Staff Report

Infill Housing Design Review Committee

File Number: 12-C-20-IH

Location: 1122 Texas Ave. Parcel ID 81 | D 036

1122 TEXAS AVE

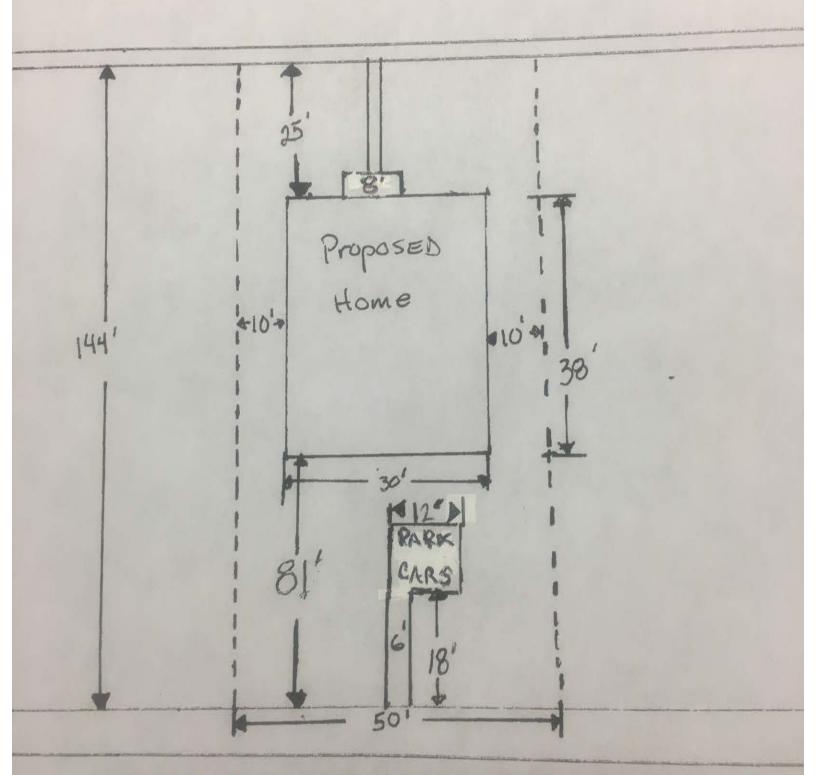
- 1. The new house is proposed to be set 25' from the front property line, with an 8' front porch set 17' from the front property line. The adjacent property is not a strong reference for the block's historic layout, as it is set substantially back from the street and turned at an angle. The proposed 25' front setback will be consistent with historic and appropriate infill properties across the street, and will set a good pattern for the remaining undeveloped lots on the property. Placement of the house will create a consistent front yard space with the surrounding context. The house incorporates a walkway from the street to the front door, perpendicular to the street.

- 2. While the block to receive new construction does not retain significant historic integrity from which to draw context, the block across the street demonstrates relatively consistent historic houses and setbacks. The proposed new house is proportional to the lot, demonstrates consistent side yard setbacks, and is compatible with the placement of historic houses on surrounding blocks.

- 3. The application includes a parking pad accessible from the alley to the rear of the property. Parking should meet City Engineering standards and be screened with landscaping. Per City Engineering, the final site plan should show a 10' wide minimum driveway connection to the alley, provide parking for at least two vehicles, with a combined driveway/parking pad measuring at least 18' by 18'. The parking area can be gravel, if contained by landscape timbers or similar, or paved concrete.

- 9. The final site plan should show a native or naturalized shade tree to be planted in front and rear yards to meet design guidelines for landscaping.

Staff recommends approval of 12-C-20-IH as submitted, with the following conditions: 1) parking to meet City Engineering standards; 2) use horizontal lap siding instead of Dutch lap to better reflect historic siding patterns; 3) incorporate one native or naturalized shade tree in front and rear yards to meet design guidelines.

Right elevation

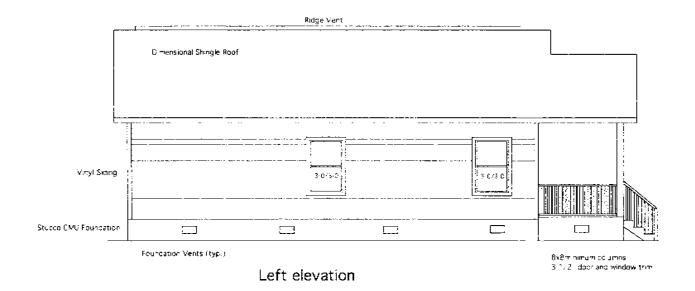
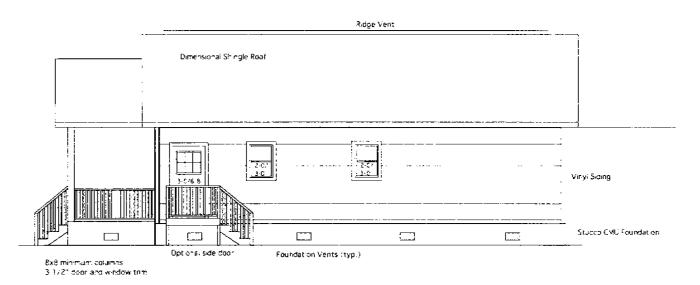
- 4. The 30' wide front façade is proportional to the house's surrounding context. The modest one-story residence with a projecting front-gable porch demonstrates a comparable massing to the surrounding context. The 2' tall foundation is appropriately sized to be compatible with nearby historic houses.

- 5. The proposed design incorporates an 8' deep, 20' wide, front-gable roof porch which meets the design guidelines. The simple 8" by 8" columns and square wood pickets are proportional for the house.

- 6. Overall, the window and door placement and design meet the design guidelines. The house contains sufficient windows on each elevation to reflect historic ratio of solids to voids, and the façade is comparable to historic façade patterns.

- 7. While the 6/12 roof pitch is shallow compared to high-style historic designs, the proposed pitch is not out of context with the surrounding blocks. The house should incorporate eave overhangs and a dark shade of dimensional shingles.

- 8. Vinyl lap siding and a stuccoed foundation meet the design guidelines for materials. The design should incorporate clapboard-style siding instead of Dutch lap or flush panels to better reflect historic siding patterns.
